Access Compliance Report

Public Rights-of-Way

(Curb Ramps)

Intersection ID: 10014410	Main Street: CORAM_PL	Cross Street: N/A	Location: E
ADA ID: B5671BFD25D6	Ramp Type: Perp	Initial Pass/Fail: Fail	Overall Compliance: No
		Severity Score: 8.75	
Codes/Mitigation Info/Possible Solution		Field Measurements/Component Compliance

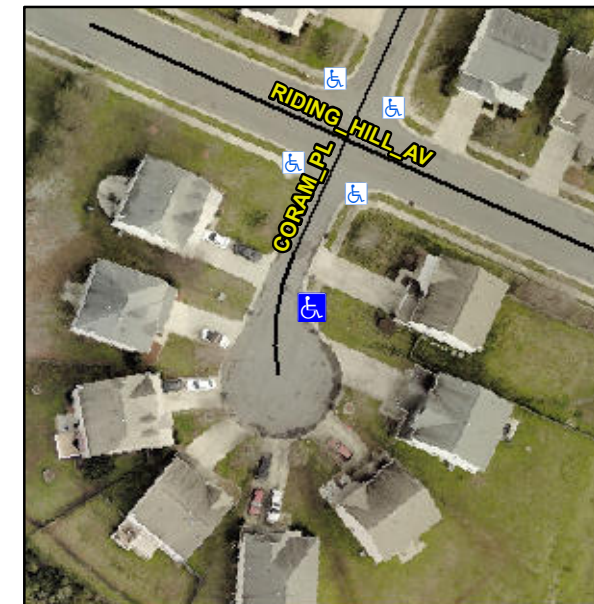
Not Found, R304.5.1

Compliance	Description	Data	Compliance	Description	Data
N/A	Ramp Length (in)	52.5	Yes	Ramp Slope (%)	5.6
No	Ramp Width (in)	46.0	Yes	Ramp XSlope (%)	0.3
N/A	Flare Type LT	N/A	N/A	Flare Type RT	N/A
N/A	Flare Slope LT (%)	N/A	N/A	Flare Slope RT (%)	N/A
N/A	Flare Traversable LT?	N/A	N/A	Flare Traversable RT?	N/A
N/A	Landing Length (in)	N/A	N/A	DWS Provided?	N/A
N/A	Landing Width (in)	N/A	N/A	DWS Contrast?	N/A
N/A	Landing Slope (%)	N/A	N/A	DWS Length (in)	N/A
N/A	Landing X Slope (%)	N/A	N/A	DWS Full Width?	N/A
N/A	Landing Curb? (Y/N)	N/A	N/A	DWS Offset (in)	N/A
N/A	Shared Landing?	N/A			
N/A	Gutter Ponding?	N/A	N/A	Gutter Slope (%)	N/A
N/A	Gutter Lip Ht (in)	N/A	N/A	Gutter X Slope (%)	N/A
N/A	Painted X Walk1?	No	N/A	Painted X Walk2?	N/A
	X Walk 1 Direction	To W		X Walk 2 Direction	N/A
N/A	X Walk 1 Width (in)	N/A	N/A	X Walk 2 Width (in)	N/A
	X Walk 1 Slope (%)	0.1		X Walk 2 Slope (%)	N/A
	X Walk 1 X Slope (%)	2.0		X Walk 2 X Slope (%)	N/A

Remove & Replace Entire Ramp.
